GW - 194

INSPECTIONS & DATA

**RE: Discharge Plan Inspections
GW-193 and GW-194
San Juan and Rio Arriba Counties, New Mexico**

PHOTO NO. 2 6/6/96

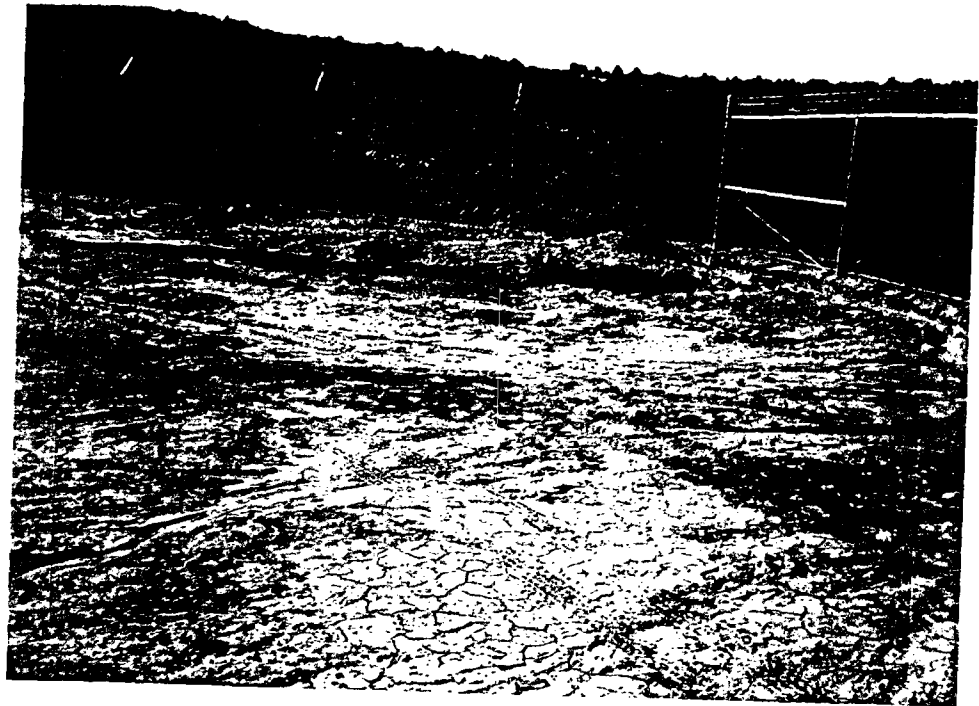
1. GW-193 or Sandstone Compressor Station, see photo No. 2 MOI GW-193.

The bermed area with-in the tank farm has signs of hydrocarbon contamination, MOI needs to clean up the soils and determine the extent of vertical and horizontal contamination, as well as look at design and operating practices at the site. (i.e. - truck load line spill containment box-the lines extend to far outward and cause liquids to be spilled outside of the box area.)

PHOTO NO.4

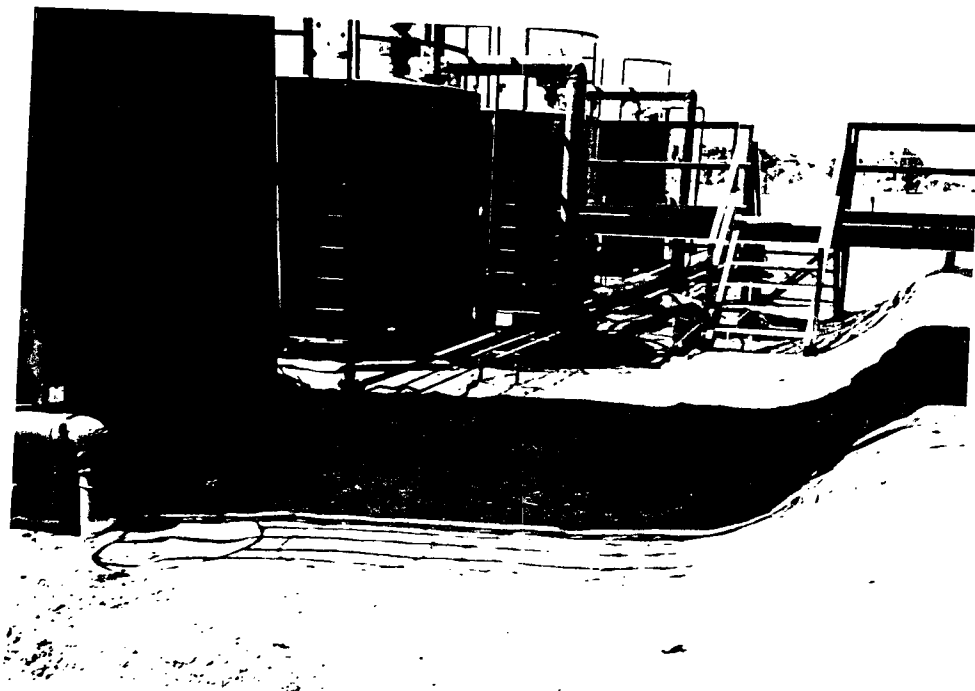
5. **GW-194 or Frances Mesa Compressor Station**, See photo No. 4 MOI GW-194, This tank area needs to addressed as required in "1. **GW-193 or Sandstone Compressor Station**," above.
